INDIANA DEPARTMENT OF TRANSPORTATION

APPROVED MINUTES

March 18, 2010 Standards Committee Meeting

REVISION TO THE STANDARD SPECIFICATIONS AND STANDARD DRAWINGS

REVISION TO THE STANDARD SPECIFICATIONS AND STANDARD DRAWINGS
 REVISION TO E 704-BDCG-03 CASTING DETAILS ROADWAY DRAIN TYPE OS

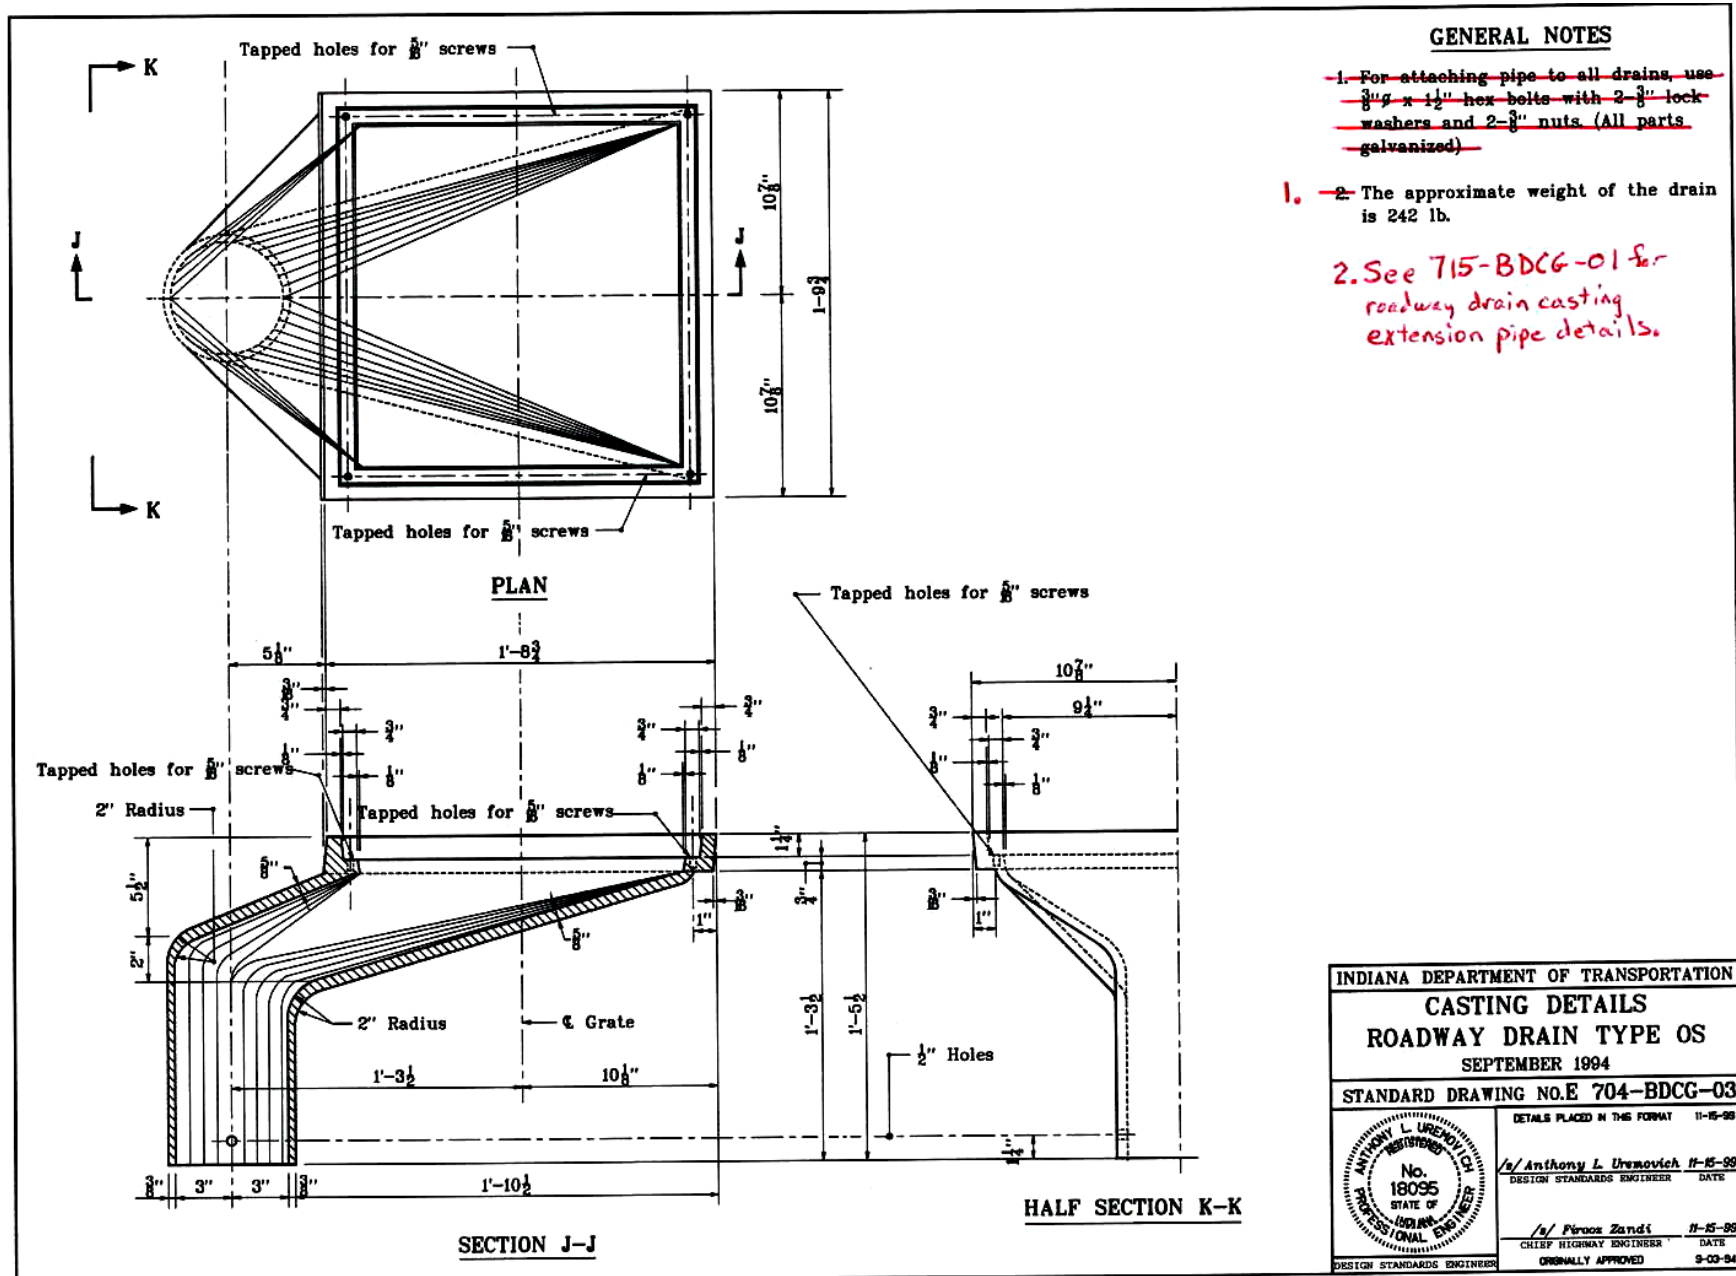
REVISION TO E 704-BDCG-04 CASTING DETAILS ROADWAY DRAIN TYPE SQ

REVISION TO E 714-BCJT-01 PRECAST REINFORCED CONCRETE BOX SECTION JOINT

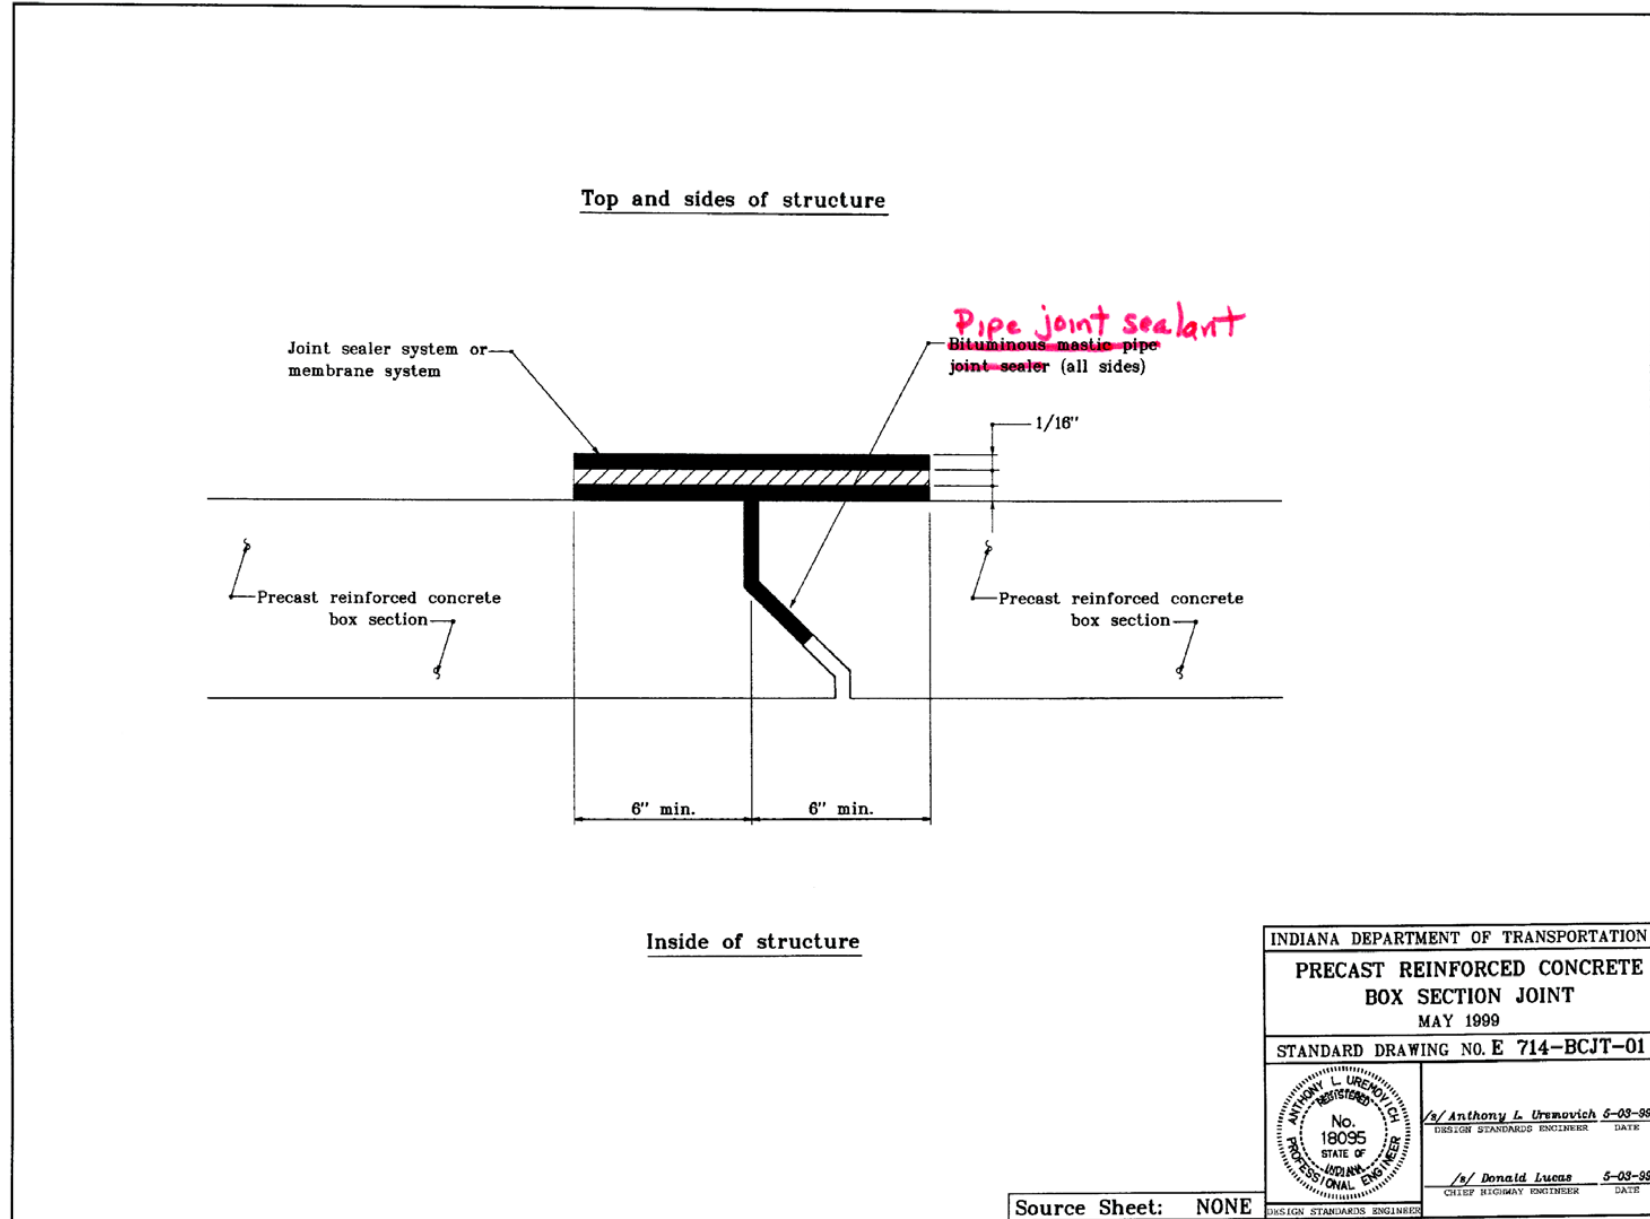
Precast reinforced concrete box section joints shall be sealed as shown on the plans. A ~~bituminous mastic pipe joint sealer~~ sealant system or self-adhering joint membrane systems shall be applied once the concrete surface temperature is above 40°F (5°C) or sufficient to allow adherence. The concrete surfaces shall be cleaned and dry prior to application of the ~~mastic or membrane~~ material. Heat may be applied to the concrete surfaces until they are in accordance with the temperature and dryness requirements. The mastic or membrane material shall be centered on both sides of the joint as it is being applied. After application, the geotextile or membrane material shall be rolled to avoid wrinkling. If the roll of geotextile or membrane material does not cover the full length of the joint, an overlap of at least 2 1/2 in. (65 mm) will be required to start the next roll of material. The manufacturer's application instructions shall apply in addition to the above requirements.
